## STAFF REPORT

### Community Planning and Preservation Commission Certificate of Appropriateness Request

<b>Case No.:</b>	<b>21-90200119</b>
Address:	1001 Bay Street Northeast
Legal Description:	BAYVIEW ADD BLK 8, W 50FT OF LOT 7
Parcel ID No.:	18-31-17-05274-008-0070
Date of Construction:	Circa 1923

Request: Review of a Certificate of Appropriateness for the replacement of historic windows at 1001 Bay Street Northeast, a contributing property to a local historic district.

**Figure 2: Floor plan showing proposed window replacement locations, highlighted in blue. The spiral staircase, marked in red, has been removed from the proposal.**

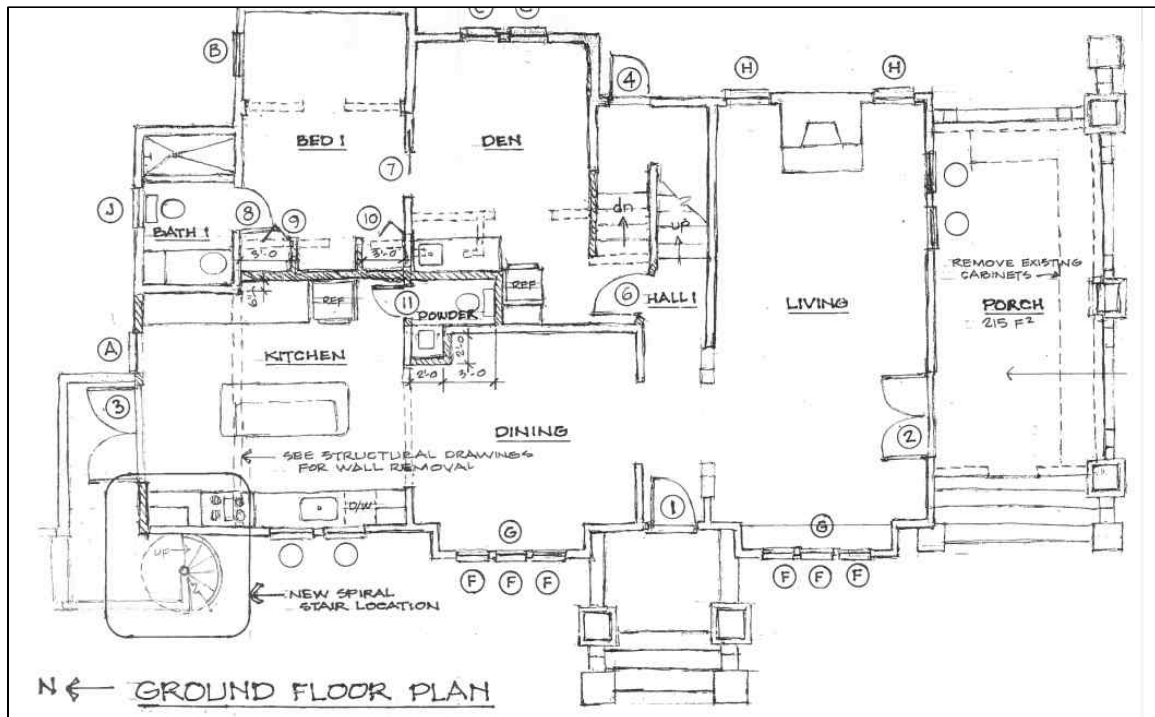
- Replacement of historic casement and fixed windows in main house with new windows to match historic window configurations on house.
  - Windows marked F, G, and H on the scope of work page, site plan, and elevations are the windows currently under review.
  - Windows marked A, B, C, D, E, and J have already been approved to be replaced with new vinyl windows under previous applications.
- ~~Construct a spiral staircase on streetside elevation.~~
  - This has been removed from the application.

We are removing the spiral staircase from the COA as of now.

Window changes:

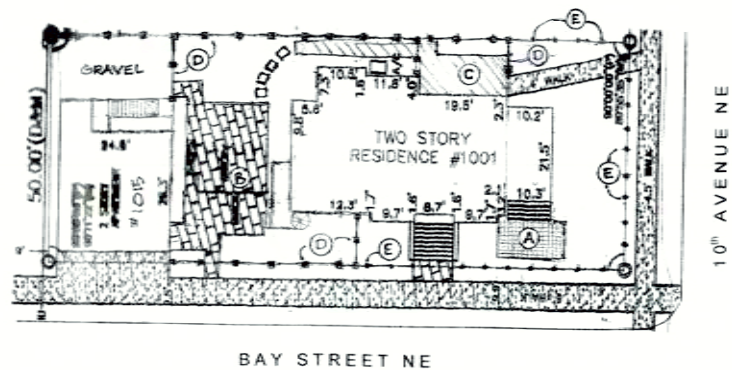
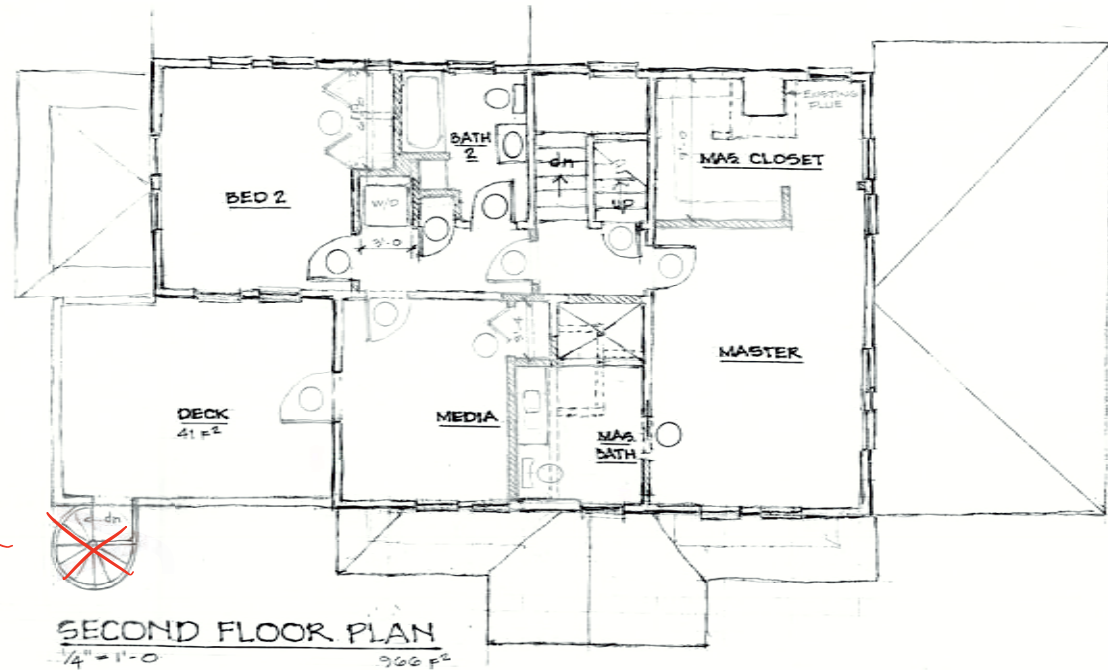
**Inconsistent** The application does include the removal of the remaining historic windows, which appear to be in good condition. No documentation was provided regarding their deteriorated condition.

**Inconsistent** While the application is silent on the proposed material, staff understands the replacement window frames will be vinyl, as indicated by the applicant through conversations and because the other windows to be replaced on the subject property were approved with vinyl frames.

- A New Window Kitchen 30-3/4" x 49-3/8" 1/1
- B New Window Bed 1 30-3/4" x 49-3/8" 1/1
- C 2-New Windows Den 30-3/4" x 49-3/8" 1/1
- D Replace same size alum window Bath 1 30-3/4" x 38-38" 1/1 Obscure
- E Replace same size alum window Loft 37" x 38" 1/1
- F Replacement Dining/Living 22-3/4" x 43-3/4" 6 lite Casement
- G Replacement Dining/Living 16-1/2" x 76-1/2" 10 lite Fixed
- H Replacement Living 30-1/4" x 22-3/8" 6 lite Fixed
- J Replacement Second Floor 30-1/4" x 22-3/8"

1. Window product information, including manufacturer details, grid profiles, and window configurations, will need to be provided to staff prior to issuance of building permits.
2. Wooden exterior casing and trim will be reinstalled in kind.

3. Windows will be installed to be setback within the wall plane and feature a reveal of at least two inches, to match existing window reveal.
4. Proposed windows will replicate existing design and configuration of each window, and feature contoured, exterior three-dimensional muntins.
5. A historic preservation final inspection will be required.
6. All other necessary permits shall be obtained. Any additional work shall be presented to staff for determination of the necessity of additional COA approval.
7. This approval will be valid for 24 months from the date of this hearing, with an expiration date of November 8, 2023.
